## Technical Notice / Note Technique / Nota Técnica

### CHANGE MADE TO THE ELECTRONIC THROTTLE BODY

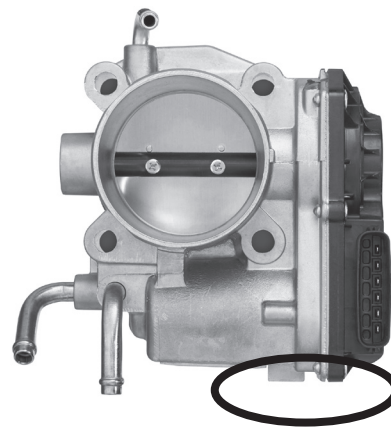
When replacing the electronic throttle, the new throttle body has a port that has been removed and is no longer in use.

The original hose that was connected to the old throttle body is simply a vent and does not require to be capped or sealed.
